## **Addendum # 4**

**2026-16**

### **GC Services for New-Build Elementary School in Cobourg**

## **PART II - REVISIONS TO SPECIFICATIONS & DRAWINGS**

### 1.3 Playground Equipment Products

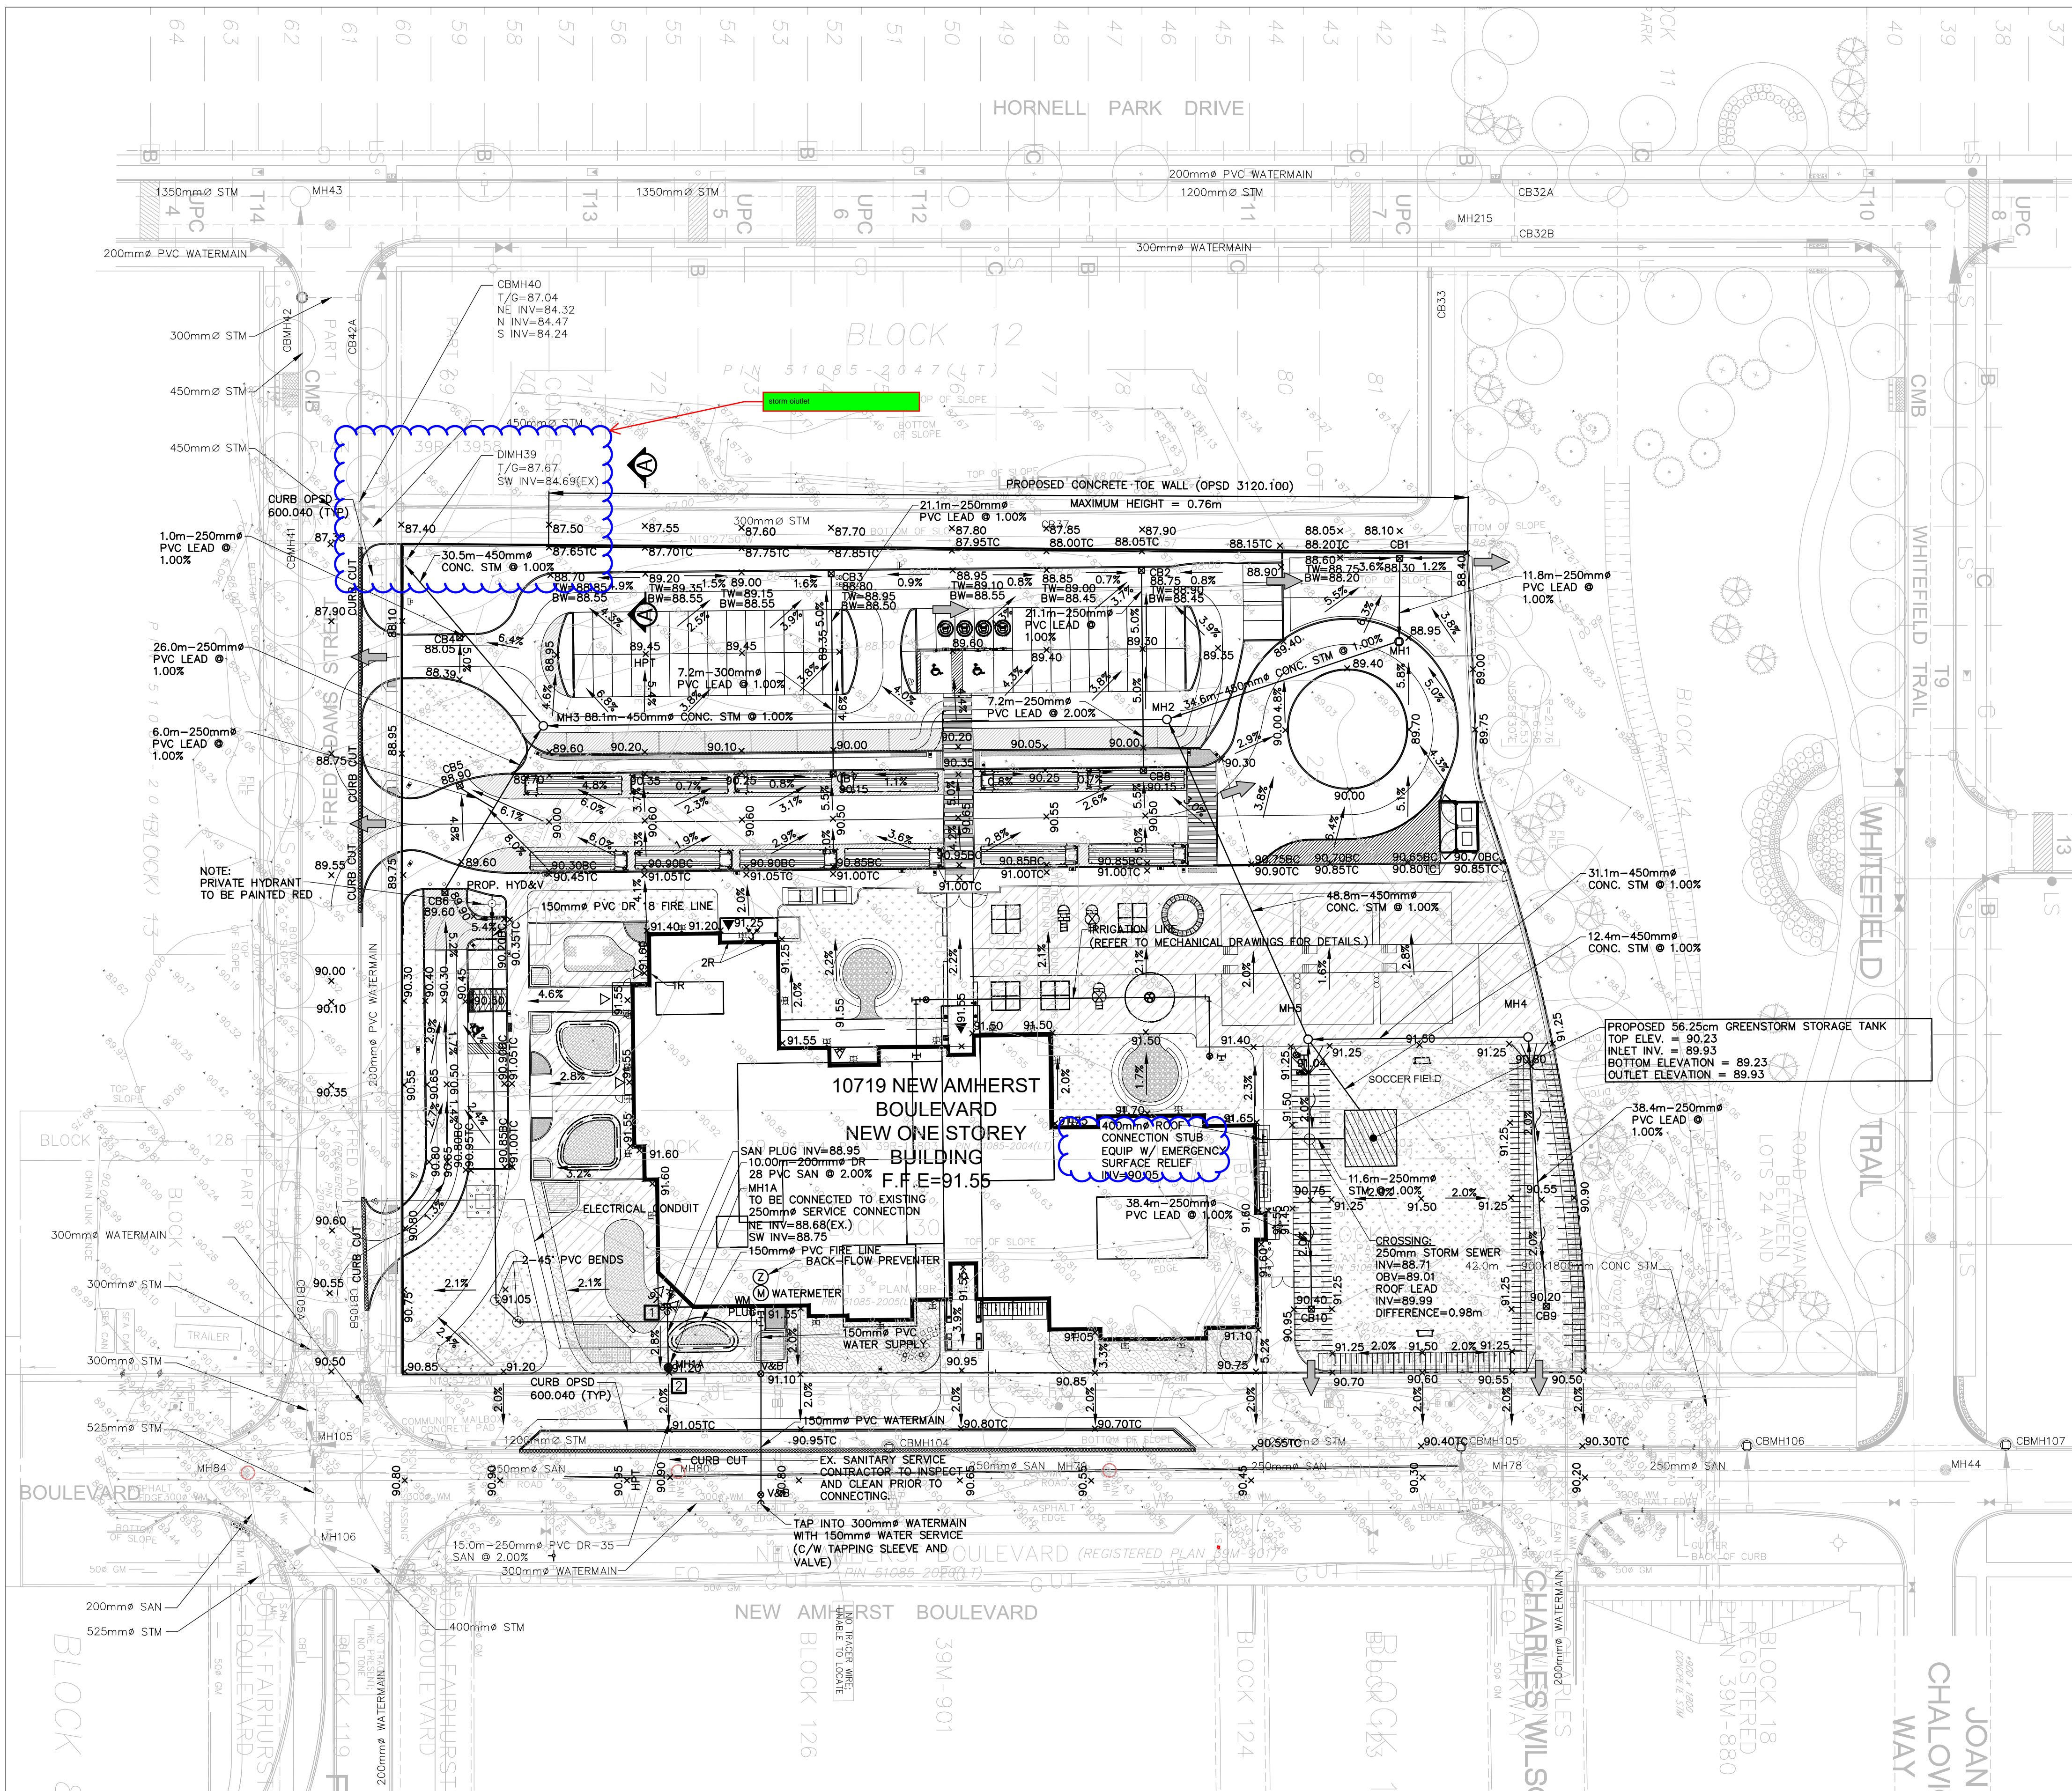
### Item 1) Playground Equipment (L-L1 Landscape Plan)

Play areas designated for equipment to be provided by the childcare operator are identified and labelled as Childcare Infant, Toddler, and Preschool Playground on the Landscape and Architectural drawings. These areas are located on the south side of the school property.

No additional information is available regarding specific equipment selections for these areas. The childcare provider shall be consulted to confirm equipment requirements.

SHEET TITLE:  
**SITE SERVICING AND GRADING PLAN**

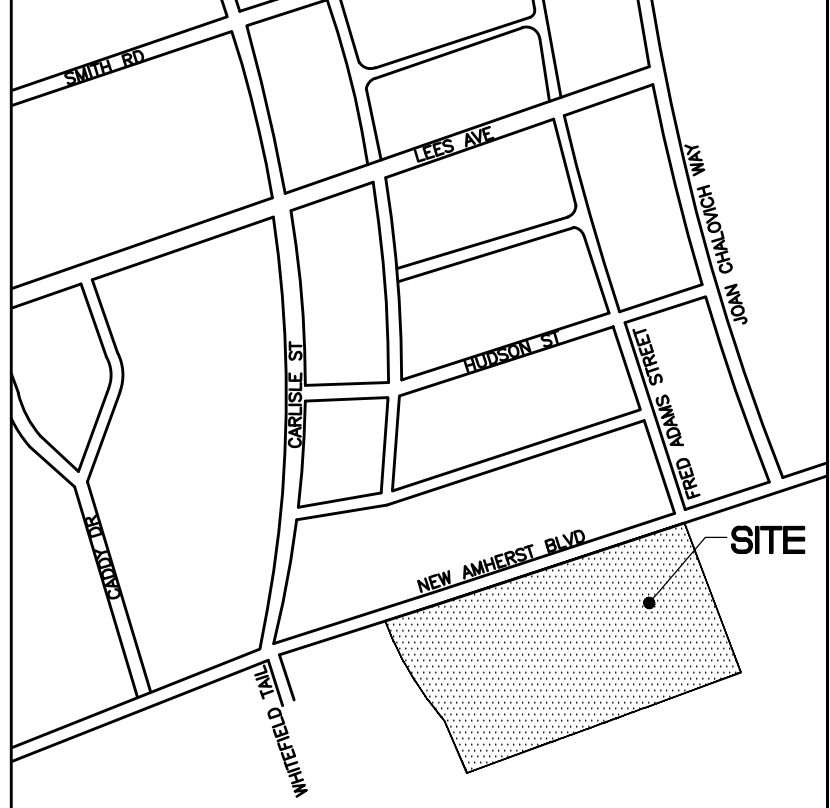
An extensive system of piping noted as STM is shown underneath paved areas and sidewalks but no outlet is shown as well no information is provided in the civil please confirm what the extent of this scope is.

NO.	DESCRIPTION	DATE	BY
1	REVISED ROOF LEADER TO INFILTRATION TANK TO 400mm	2026.04.16	S.D.L.
2	RESPOND TO PLUMBING COMMENTS	2025.12.03	S.D.L.
3	RE-ISSUED FOR SPA	2025.05.28	S.D.L.
4	ISSUED FOR BUILDING PERMIT	2025.03.14	S.D.L.

**The outlet is connected to the existing DIMH39 located at the northeast corner of the site as shown on drawing SG1 Site Servicing and Grading Plan included within this addendum.**

**Refer to drawing SG1 SITE SERVICING AND GRADING included within this addendum**
